UNITED STATES PATENT AND TRADEMARK OFFICE

APPLICATION NO.	FILING DATE	FIRST NAMED INVENTOR	ATTORNEY DOCKET NO.	CONFIRMATION N
10/658,251	09/09/2003	Geronimo E. Lat	14305	4121
7590 08/09/2004			EXAMINER	
LISA M. SOLTIS ILLINOIS TOOL WORKS INC.			SHARP, JEFFR	EY ANDREW
3600 WEST LAKE AVENUE			ART UNIT	PAPER NUMBER
GLENVIEW, I	L 60025		3677	·

DETAILED ACTION

Figure 1. Crooks US-2,314,481 – fastener

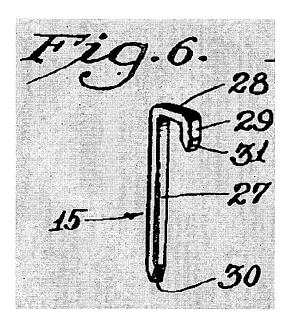
Crooks discloses a fastener (15) comprising: a bridge portion (28); a first prong (27) extending in a driving direction from said bridge portion; and a second prong (29) spaced from said first prong and extending generally parallel thereto in the driving direction from said bridge portion; wherein said second prong is substantially shorter than said first prong (See Figure 1 Crooks US-2,314,481).

As for claim 2, see Figure 1 above.

As for claim 5, see Figure 1 above.

As for claim 6, see Figure 1 above.

Figure 2. Crooks US-2,314,481 – strip of fasteners

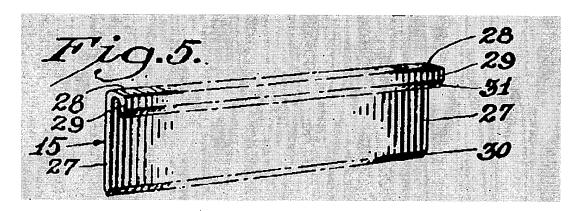
Crooks also discloses a strip of fasteners comprising: a plurality of fasteners connected together in a side-by-side array, wherein each fastener includes a bridge portion, a first prong extending in a driving direction from said bridge portion, and a second prong spaced from said first prong and extending generally parallel thereto in the

driving direction from said bridge portion, wherein said second prong is substantially shorter than said first prong; wherein each one of said first prongs is aligned generally in a first plane and each one of said second prongs is aligned generally in a second plane so as to form said strip of fasteners (See Figure 2 Crooks US-2,314,481).

As for claim 10, see Figure 2 above.

As for claim 12, see Figure 2 above.

As for claim 13 see Figure 2 above.
